dsPIC33EVXXXGM00X/10X Family Silicon Errata and Data Sheet Clarification

The dsPIC33EVXXXGM00X/10X family devices that you have received conform functionally to the current Device Data Sheet (DS70005144E), except for the anomalies described in this document.

FIGURE 1:

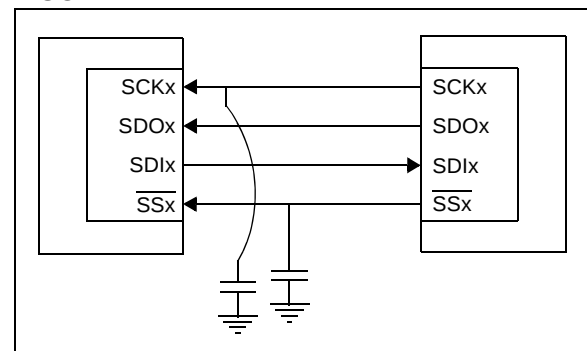
When the SPIx module is configured in SPIx Slave mode (MSTEN bit (SPIxCON1<5>) = 0), the frame slave (FRMEN bit (SPIxCON2<15>) = 1) and the SPIFSD bit (SPIxCON2<14>) = 1), in Standard Buffer mode with the Clock Polarity Select bit, CKP = 0, the data is not transmitted in both 8-bit and 16-bit mode, but the data is being received correctly.

Adding a capacitance on the signal, as shown in Figure 1, will help the data to be received properly.

FIGURE 2: TIMING DIAGRAMS FOR CENTER-ALIGNED AND EDGE-ALIGNED MODES

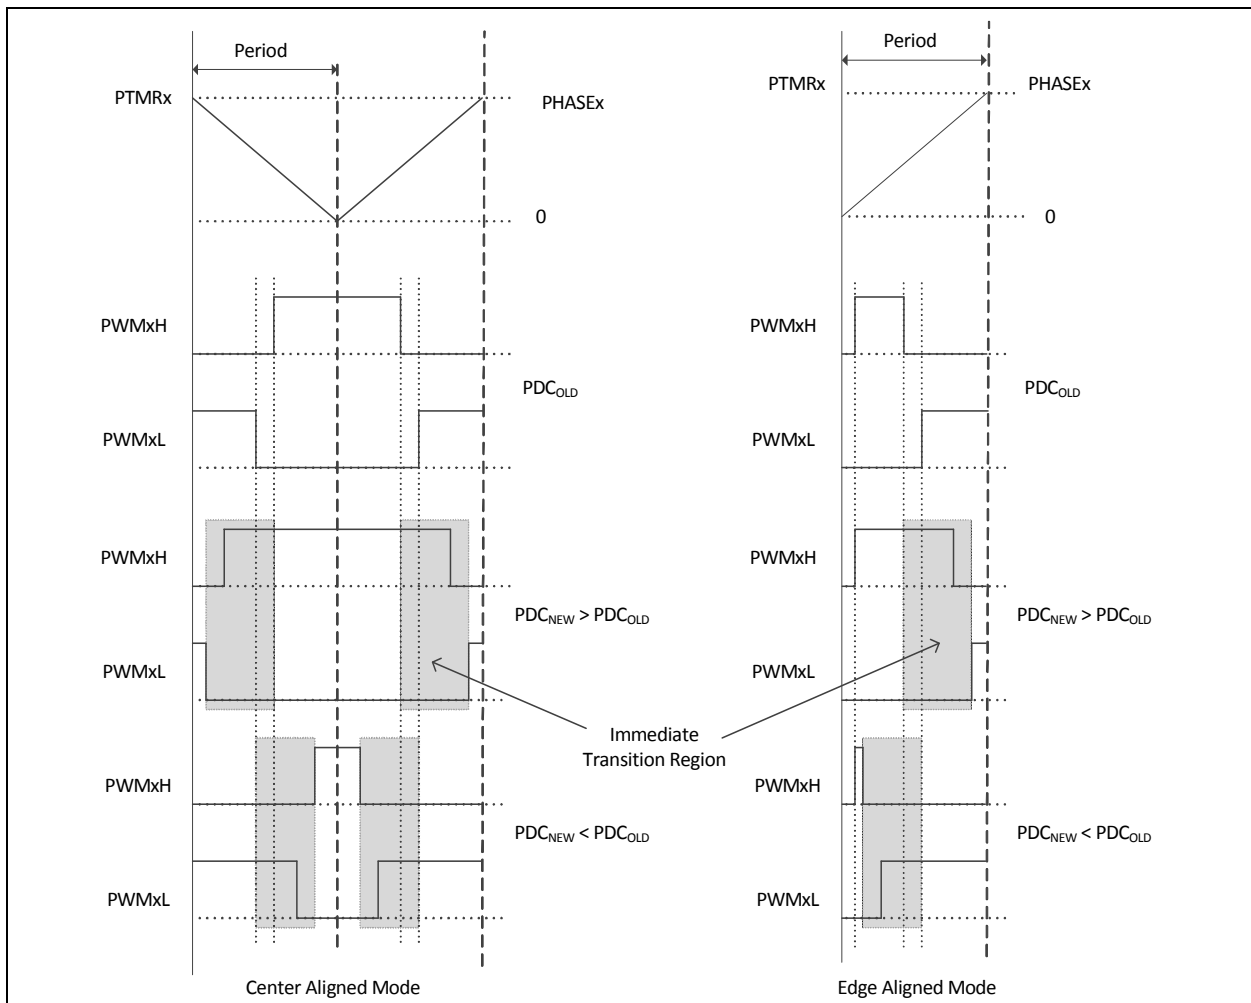
The PWM generator may not assert dead time on the edges of transitions. This has been observed when all of the following conditions are present:

In [Figure 2](#), if the duty cycle write occurred in the shaded box, then PWMxH and PWMxL will make an immediate transition without dead time.

However, in most applications, the duty cycle update timing can be controlled using the TRIGx trigger or Special Event Trigger, such that the above mentioned conditions are avoided altogether.

FIGURE 3: ILLUSTRATION OF 1 T_{osc} GLITCH WHEN PWM OVERRIDE IS TURNED OFF

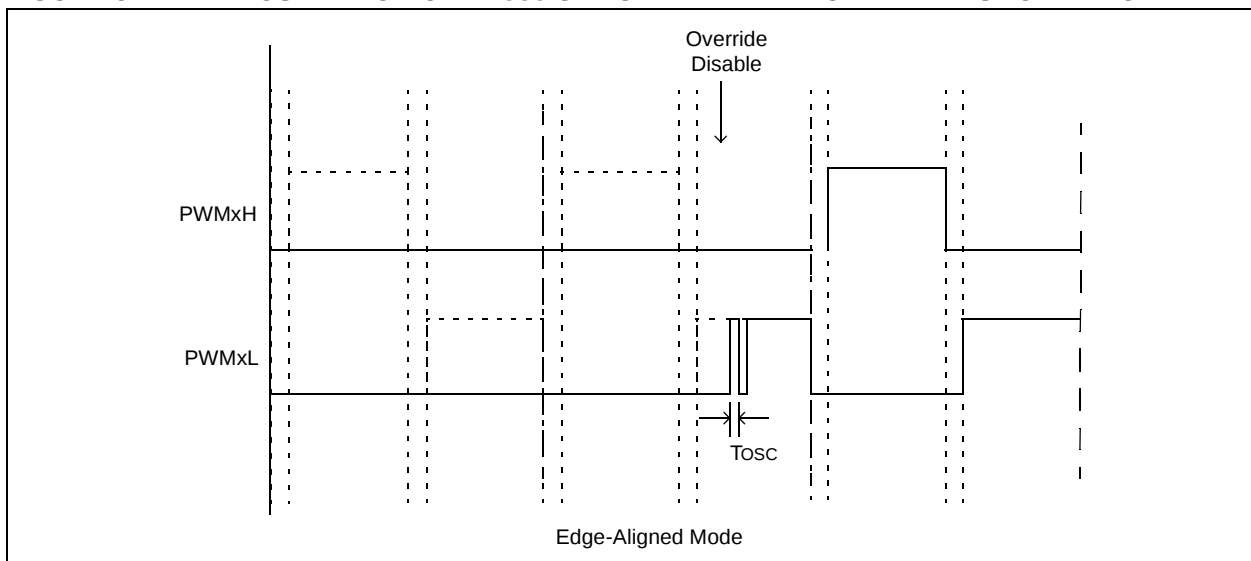
In Complementary mode after the PWM module is enabled (PTEN = 1), if the PWM override is turned off, a 1 T_{osc} glitch will be present on the rising edge of either the PWMxH or PWMxL pins, whichever occurs first, as shown in Figure 3.

The glitch will be present on PWMxH/PWMxL every time the override state is changed from override enabled to override disabled. The width of this glitch is equal to 1 T_{osc} when PCLKDIV<2:0> (PTCON2<2:0>) = 000. Increasing the PWMx input clock prescaler setting will increase the width of the glitch accordingly.

FIGURE 4:

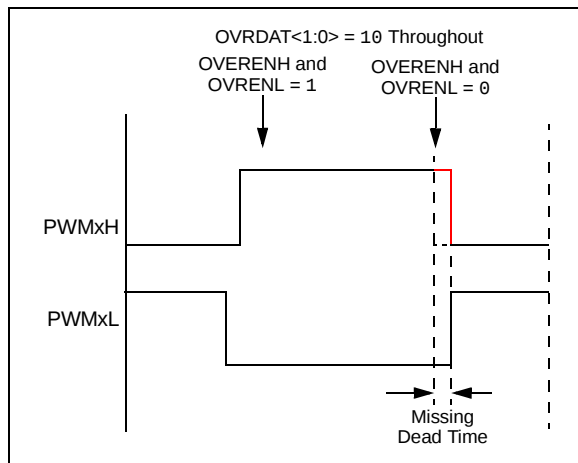
In Complementary Output mode, the expected dead time between transitions of the PWMxH and PWMxL outputs may not be asserted when the following occurs:

- Output override synchronization is configured to occur on the CPU clock boundary (IOCONx<0> = 0);
- Both PWMxH and PWMxL overrides are enabled prior to the event (OVRENH and OVRENL are both '1'), and
- Both overrides are disabled (OVRENH and OVRENL are both '0') at the instant the dead time should be asserted (Figure 4). This has been observed in both Center-Aligned and Edge-Aligned modes.

FIGURE 5:

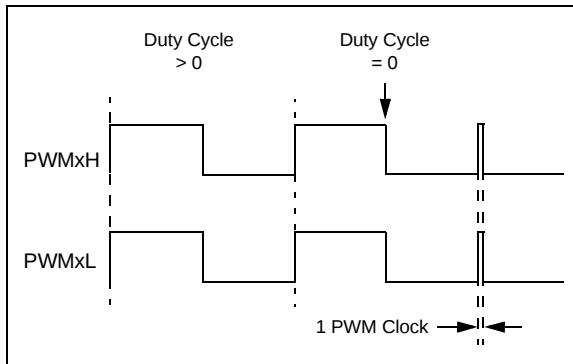
In the Redundant Output mode (IOCONx<11:10> = 10) and Push-Pull Output mode (IOCONx<11:10> = 01) with Immediate Update disabled (PWMCONx<0> = 0), when the Duty Cycle register is updated from a non-zero value to zero, a glitch pulse of a width equal to 1 PWM clock will appear at the next PWM period boundary, as shown in Figure 5, for the Redundant Output mode. Here, the Duty Cycle register refers to the PDCx register if PWMCONx<8> = 0 or the MDC register if PWMCONx<8> = 1.

If the application requires a zero duty cycle output, there are two possible work around methods:

1. Use the PWM override feature to override the PWM output to a low state instead of writing to the Duty Cycle register. In order to switch back to a non-zero duty cycle output, turn off the PWM override. The override-on and override-off events must be timed close to the PWM period boundary if the IOCONx register has been configured with IOCON<0> = 0 (i.e., output overrides via the OVDDAT<1:0> bits occur on the next CPU clock boundary).

2. Enable the Immediate Update (PWMCONx<0> = 1) while configuring the PWM module, i.e., before enabling the PWM module (PTCON<15> = 1). With Immediate Update enabled, writes to the Duty Cycle register can have an immediate effect on the PWM output. Hence, duty cycle write operations must be timed close to the PWM period boundary in order to avoid distortions in the PWM output.

FIGURE 6:

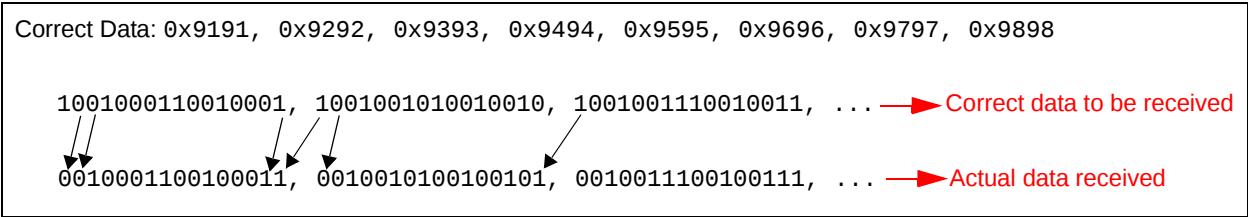
Received data of the SPI is sampled one clock cycle late for the following conditions:

For example, the correct data that should be received is 0x9191, 0x9292, 0x9393, 0x9494, 0x9595, 0x9696, 0x9797, 0x9898, but the actual data received is 0x2323, 0x2525, 0x2727, 0x2929, 0x2B2B, 0x2D2D, 0x2F2F, 0x3130 (Figure 6).
